**XK/XJ SERIES  
VEHICLE CARE  
HANDBOOK  
SUPPLEMENT  
JJM 10 16 18/001**

## Engine Lubrication System

This information complements/replaces the existing information in Section 3 - Routine Checks, related to engine oil capacity and checking the oil level.

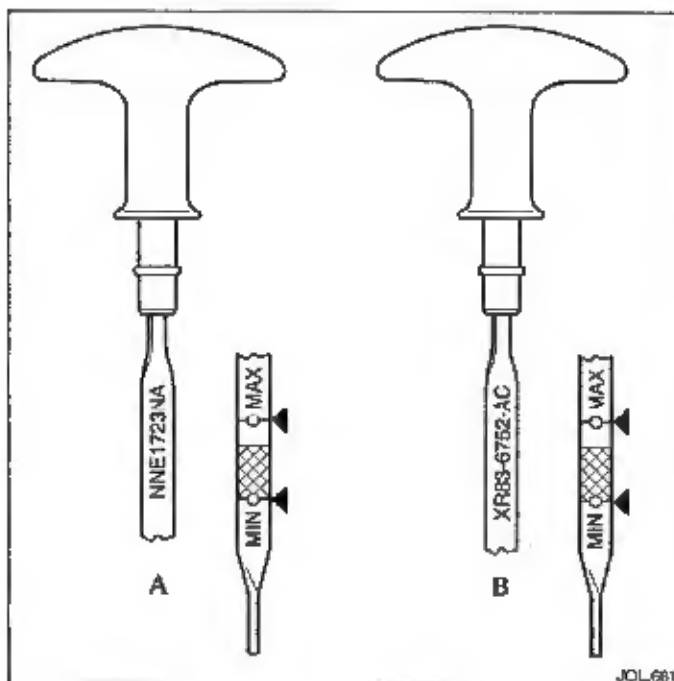
Modifications have been made to the engine lubricating system, part of which, is a new dipstick and an increase in oil capacity.

Both versions of the dipstick look similar, but may be identified by the part number stamped near the top. These are:

Pre-modification ('A' on illustration) - NNE1723NA.

Modified version ('B' on illustration) - XR83-6752-AC.
